Vehicle Standard (Australian Design Rule) Amendment Instrument 2024 (No.1)

SCHEDULE 1 – AMENDMENTS**Vehicle Standard (Australian Design Rule 99/00 – Lane Departure Warning Systems) 2023**

SCHEDULE 2 – AMENDMENTS**Vehicle Standard (Australian Design Rule 14/03 – Devices for Indirect Vision) 2023**

SCHEDULE 3 – AMENDMENTS**Vehicle Standard (Australian Design Rule 14/02 – Rear Vision Mirrors)
2006**

[1] Paragraph 2.3 of Annex 6 to Appendix A, amend to read:

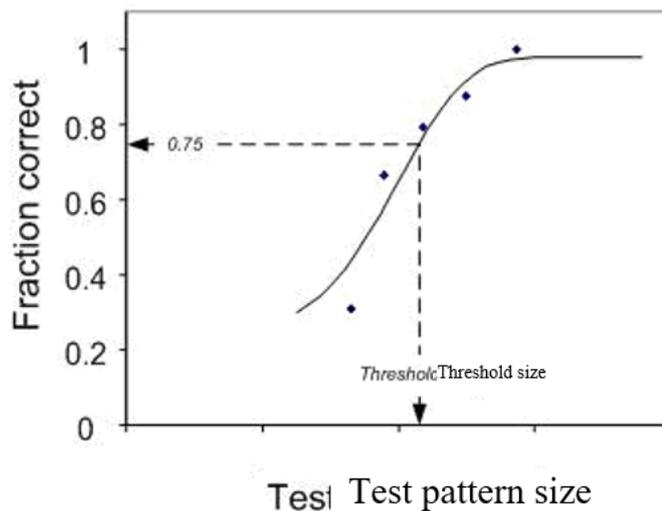
“2.3. Geometrical conditions

The angle of the incident beam (Θ) should preferably be 0.44 ± 0.09 rad ($25 \pm 5^\circ$) from the perpendicular to the test surface and shall not exceed the upper limit of the tolerance (i.e. 0.53 rad or 30°). The axis of the receptor shall make an angle (Θ) with this perpendicular equal to that of the incident beam (see Figure 1). The incident beam upon arrival at the test surface shall have a diameter of not less than 13 mm (0.5 inch). The reflected beam shall not be wider than the sensitive area of the photodetector, shall not cover less than 50 per cent of such area, and as nearly as possible shall cover the same area segment as used during instrument calibration.

When an integrating sphere is used in the receiver section, the sphere shall have a minimum diameter of 127 mm (5 inch). The sample and incident beam apertures in the sphere wall shall be of such a size as to admit the entire incident and reflected light beams. The photodetector shall be so located as not to receive direct light from either the incident or the reflected beam.”

[2] Paragraph 1.1.2 of Annex 10 to Appendix A;

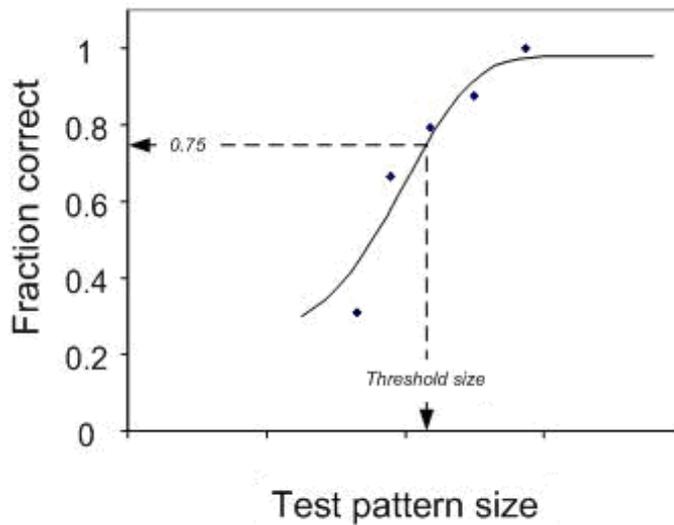
Omit:

Substitute:
